SERVICE BULLETIN
CHECKING OR REPLACEMENT
OF FUEL PUMP PART NO. 892230/892235
FOR ROTAX® ENGINE TYPE 912 (SERIES)
SB-912-050UL

SB-912-050

Checking or replacement of fuel pump part no. 892230/892235 for ROTAX® engine type 912 (Series).

(see Fig.1)

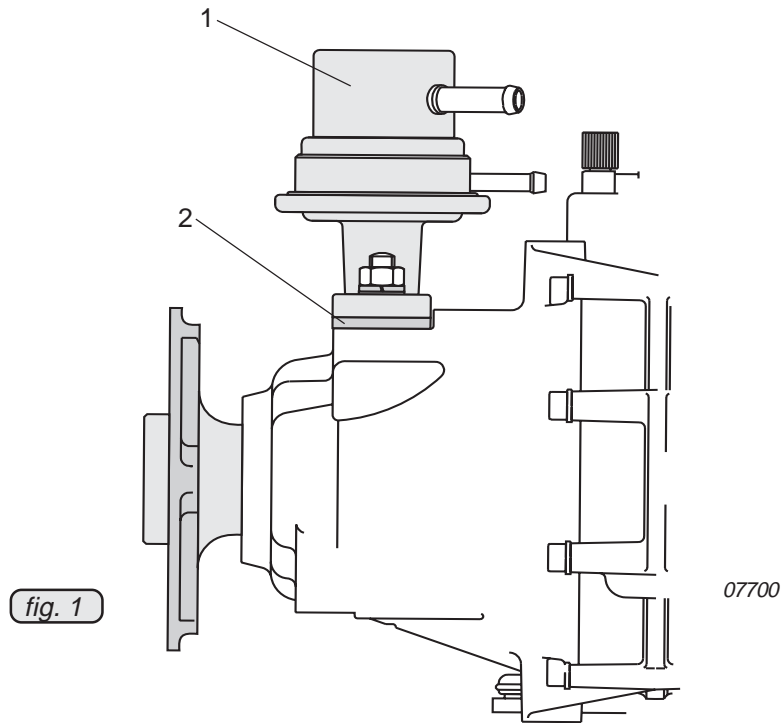
Geometry changes of the gasket can result in limited cases in subsidence and leakage. Therefore gasket (2) must be replaced by new part for all engines affected (See Fig 1).

- Remove fuel pump (1).
- Gasket (2) replaced by new part.
- Install fuel pump. Tightening torque 15 Nm (133 in.lb).
- Install fuel line.
- Restore aircraft to original operating configuration.
- Connect negative terminal of aircraft battery.
